ADDENDUM No. 1

Project Name:	Owner: City of Dexter Project Name: Dexter City Hall Renovations	Addendum No: One (1)
Project Number:	21-113	Issue Date: January 21, 2022
Project Location:	3515 Broad St. Dexter, Michigan 48130

WALL SECTIONS

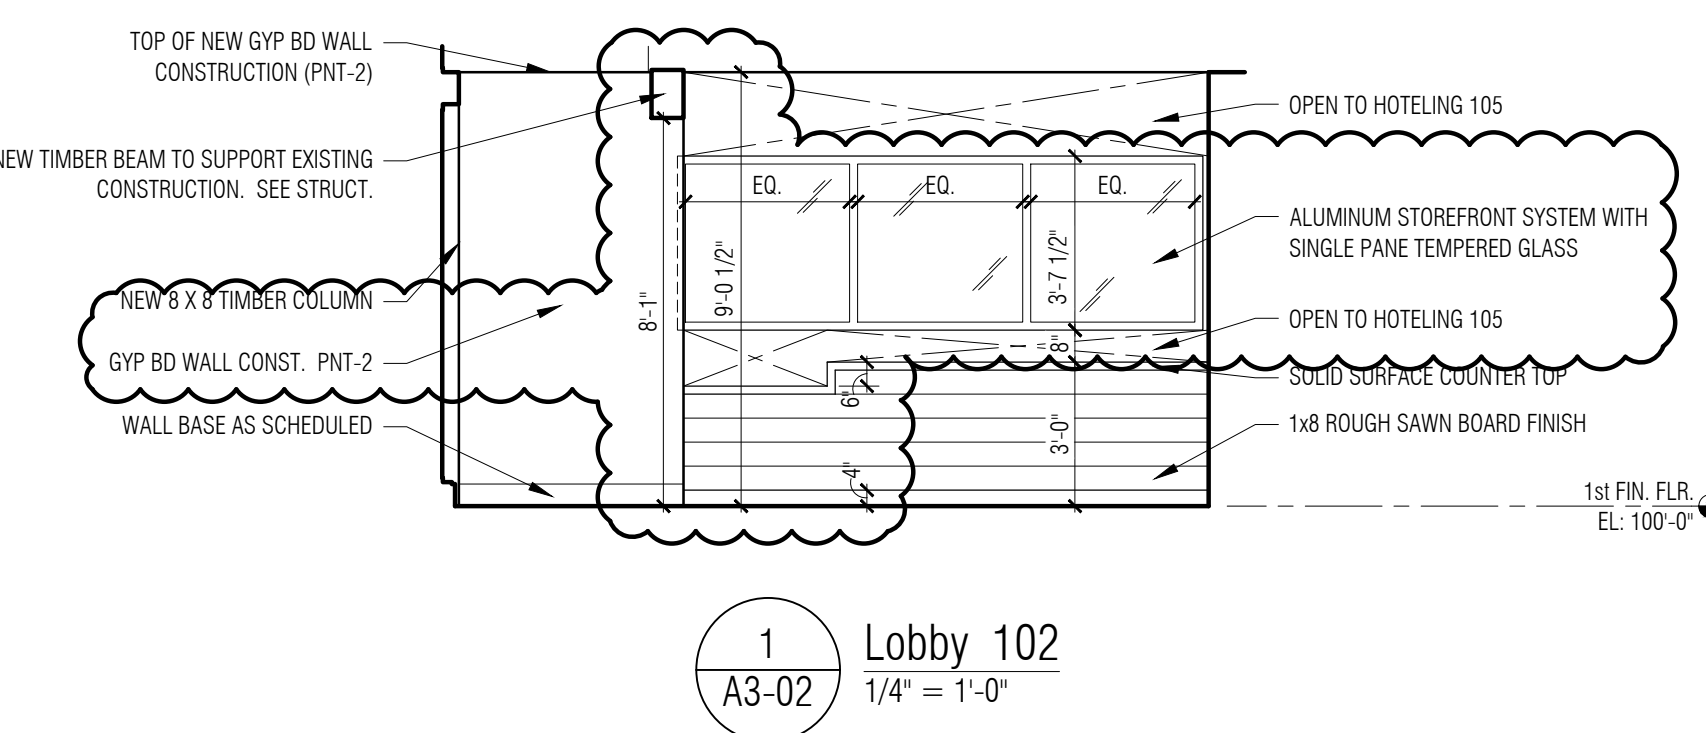
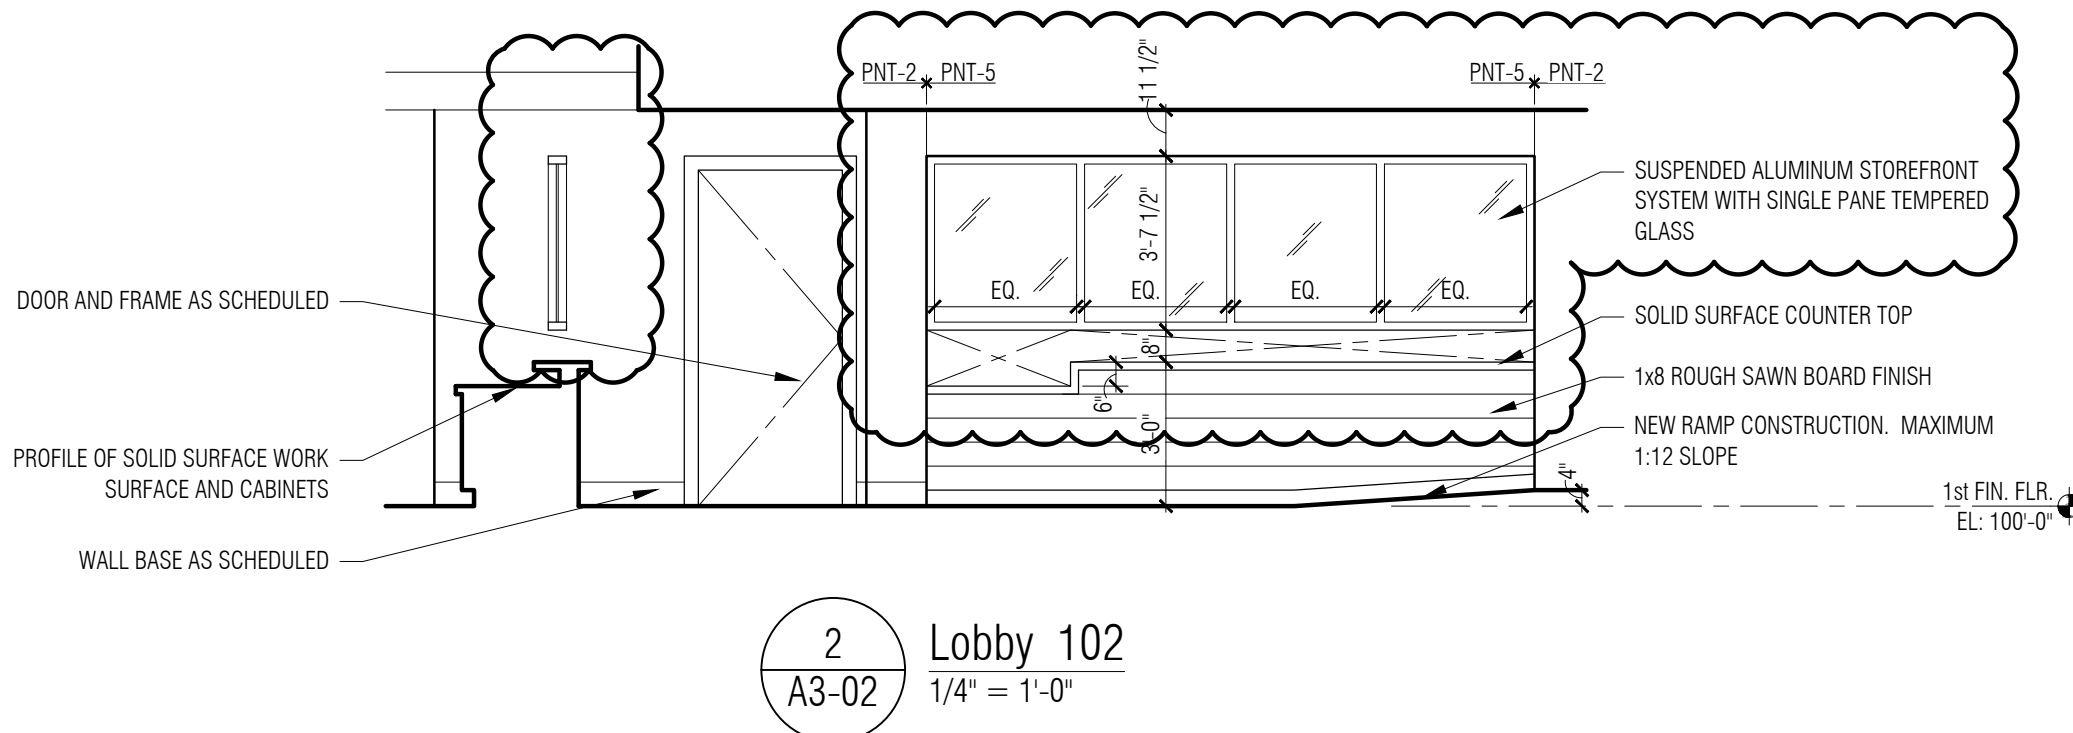
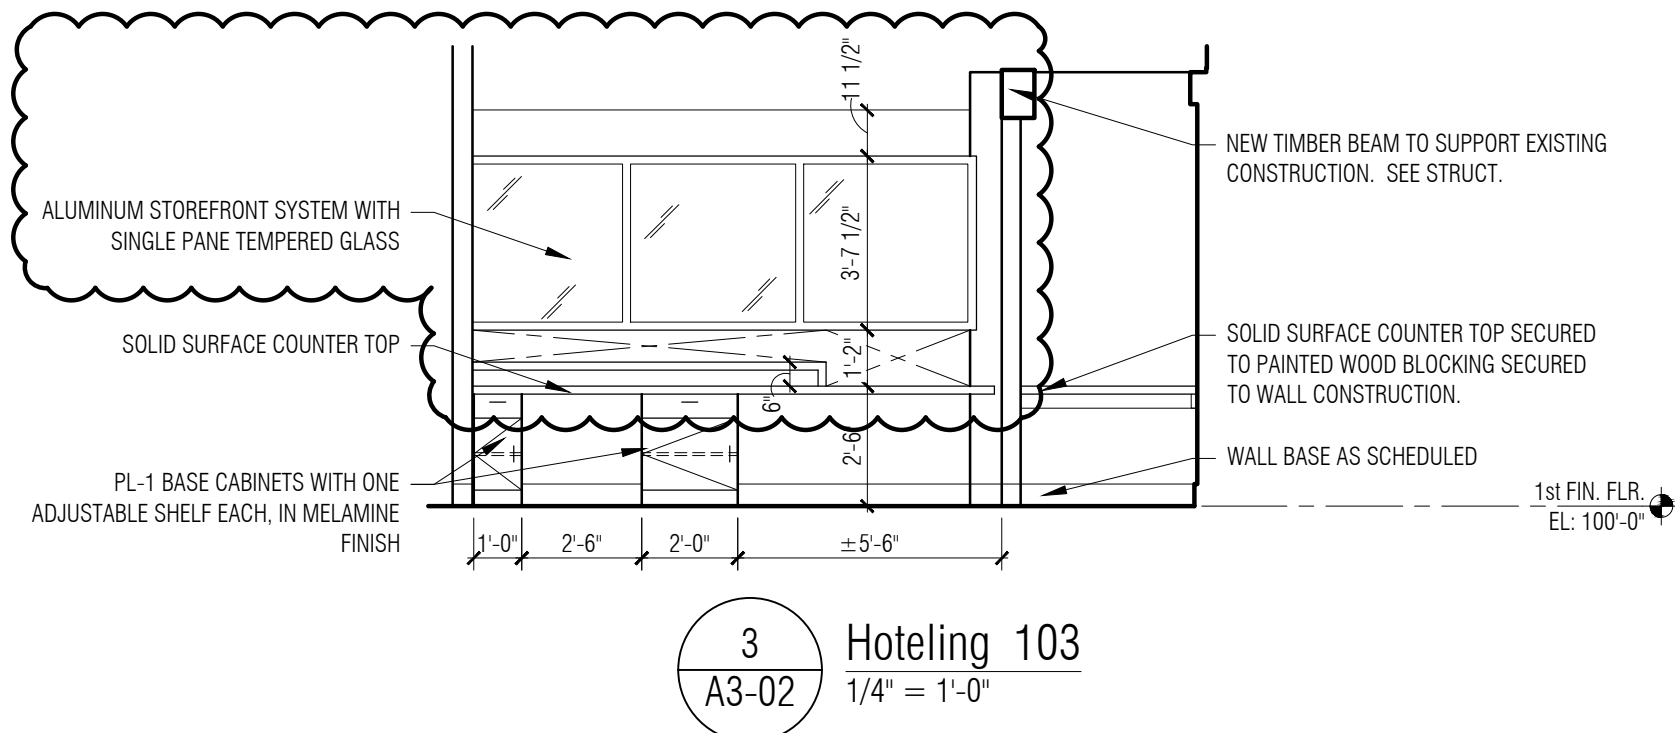
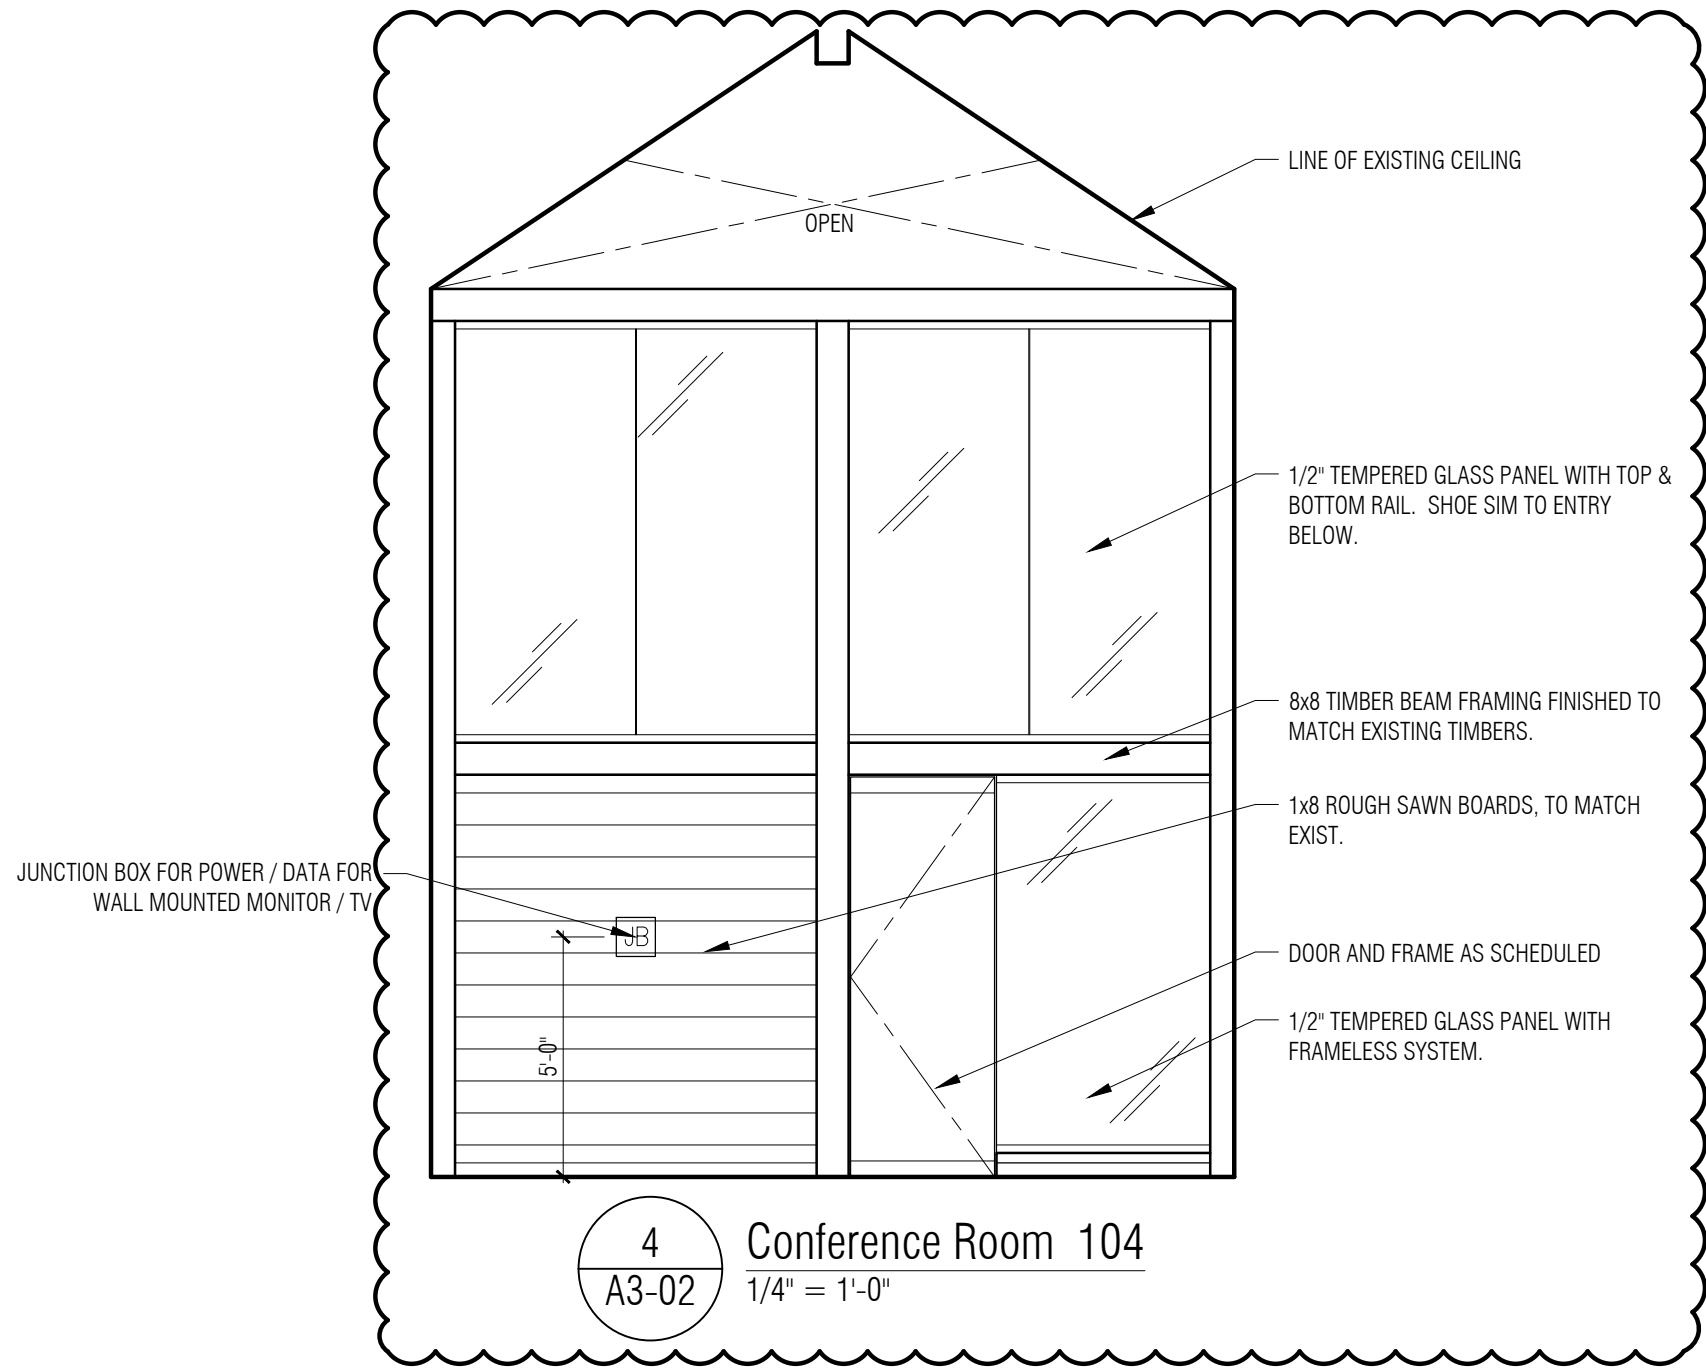
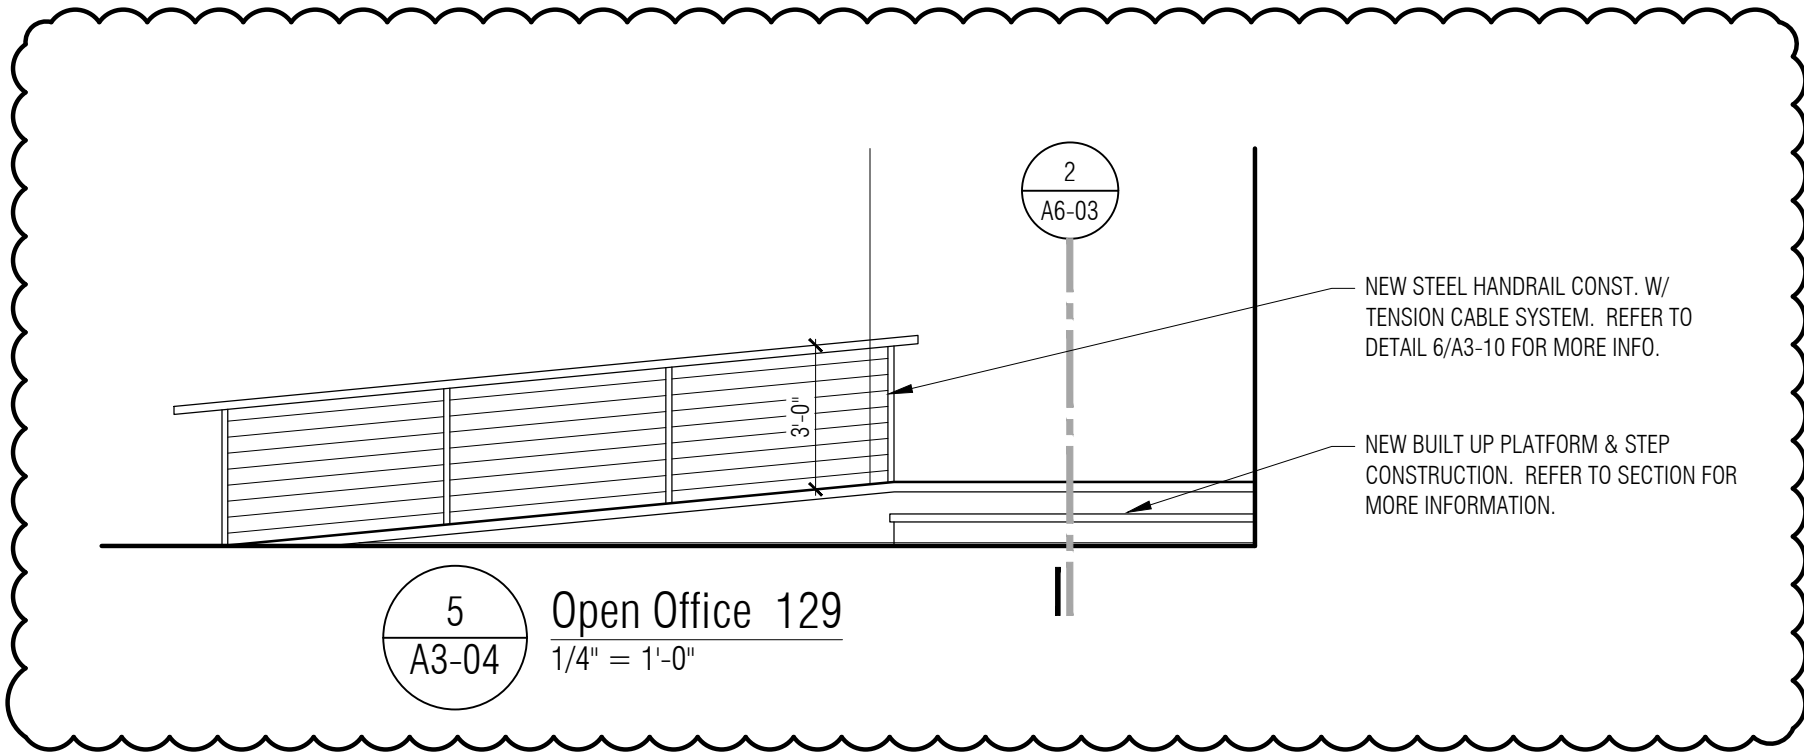
- ITEM A22** A6-01 Wall Sections (Revised & Re-Issued)
- A. Updated section 1 to show new beam as timber.
 - B. Updated notes on sections 1 & 4 to call out 3/8" tempered glass, rather than 1/4"; and that neoprene gasket to go all around.

- C. Updated elevation target on section 1 to clarify top of wall should align with existing timbers.
 - D. Updated note on section 2 @ upper-level window to clarify that work is part of deduct alternate #5, and top of window should align with existing windows.

- E. Updated note on section 3 to clarify that glass should be safety glass due to short distance between stair landing and window stool.
 - F. Updated floor detail @ elevator on section 5.

MAIN LEVEL
LIGHTING PLAN

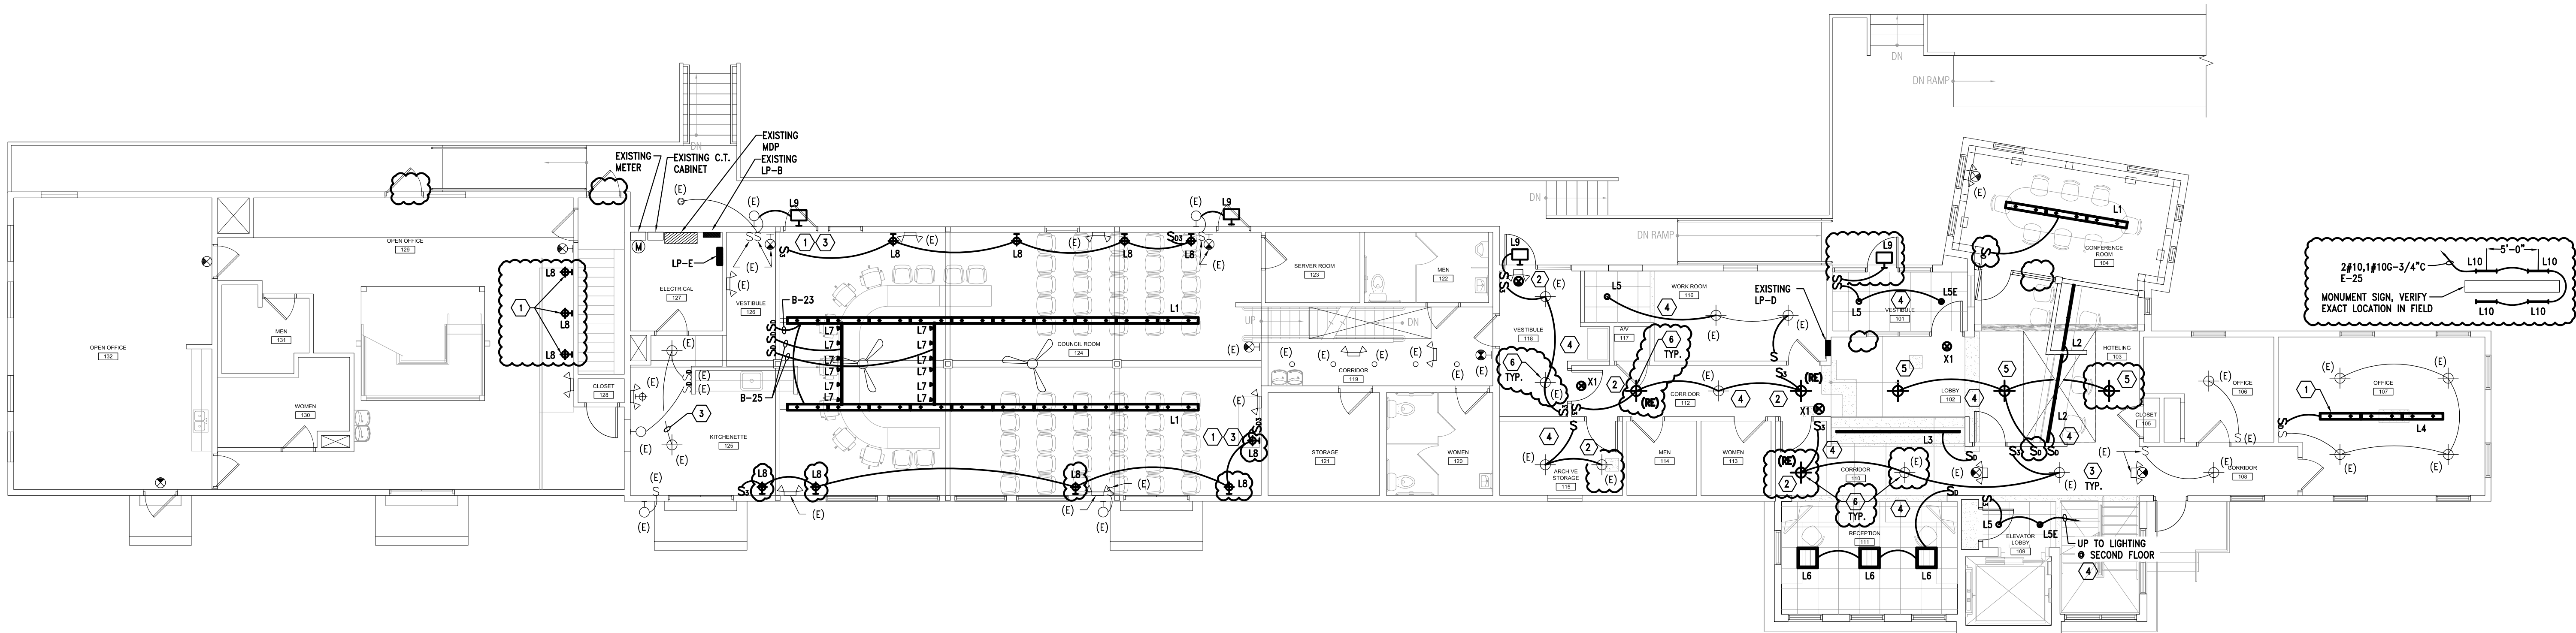
- ITEM E1** E1-01 (Revised & Re-Issued)
A. Add provisions for ground mounted sign.
B. Adjusted lighting at deleted elevator lobby closet.
C. Add surface mounted fixture type to match existing fixtures.
D. Add LED replacement lamps for all existing and relocated surface mount light fixtures.
E. Add type L9 light fixture.
F. Adjust switching in Lobby 102 and Conference room 104.
G. Adjust lighting in Archive Storage 115.
H. Denoted light fixture type in Council 124 for clarification.
I. Add wall mounted lighting in Open Office 129.
J. Delete existing wall mount outdoor fixtures.
- ITEM E2** E1-02 (Revised & Re-Issued)
A. Denoted light fixture type in west Conference room.
